Access Compliance Report

(Curb Ramps)

Intersection ID: 14195	Main Street: CLEVELAND_AV	Cross Street: EAST_BV	Location: SW
ADA ID: 6B700EC37540	Ramp Type: Perp	Initial Pass/Fail: Fail	Overall Compliance: No
Severity Score: 13.75			
Codes/Mitigation Info/Possible Solution		Field Measurements/Component Compliance

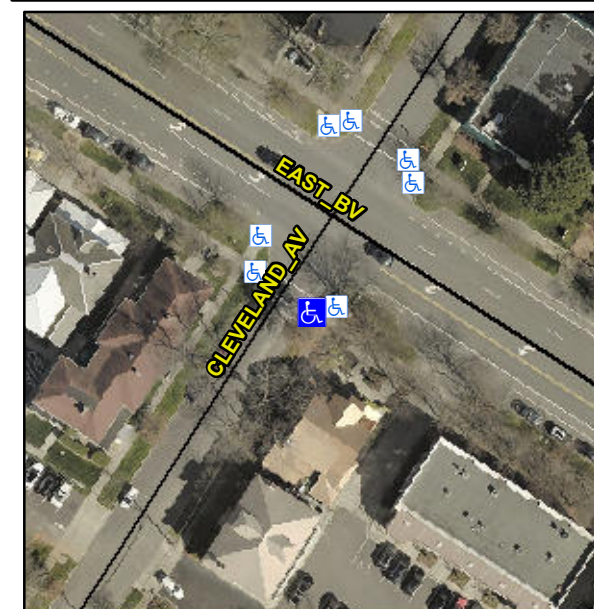
Not Found, R304.2.2, R304.5.3

Compliance	Description	Data	Compliance	Description	Data
N/A	Ramp Length (in)	67.0	No	Ramp Slope (%)	8.7
Yes	Ramp Width (in)	73.0	No	Ramp XSlope (%)	3.1
N/A	Flare Type LT	N/A	N/A	Flare Type RT	N/A
N/A	Flare Slope LT (%)	N/A	N/A	Flare Slope RT (%)	N/A
N/A	Flare Traversable LT?	N/A	N/A	Flare Traversable RT?	N/A
N/A	Landing Length (in)	N/A	N/A	DWS Provided?	N/A
N/A	Landing Width (in)	N/A	N/A	DWS Contrast?	N/A
N/A	Landing Slope (%)	N/A	N/A	DWS Length (in)	N/A
N/A	Landing X Slope (%)	N/A	N/A	DWS Full Width?	N/A
N/A	Landing Curb? (Y/N)	N/A	N/A	DWS Offset (in)	N/A
N/A	Shared Landing?	N/A			
N/A	Gutter Ponding?	N/A	N/A	Gutter Slope (%)	N/A
N/A	Gutter Lip Ht (in)	N/A	N/A	Gutter X Slope (%)	N/A
N/A	Painted X Walk1?	Yes	N/A	Painted X Walk2?	N/A
	X Walk 1 Direction	To NW		X Walk 2 Direction	N/A
N/A	X Walk 1 Width (in)	110.0	N/A	X Walk 2 Width (in)	N/A
	X Walk 1 Slope (%)	6.9		X Walk 2 Slope (%)	N/A
	X Walk 1 X Slope (%)	3.6		X Walk 2 X Slope (%)	N/A

Remove & Replace Entire Ramp.
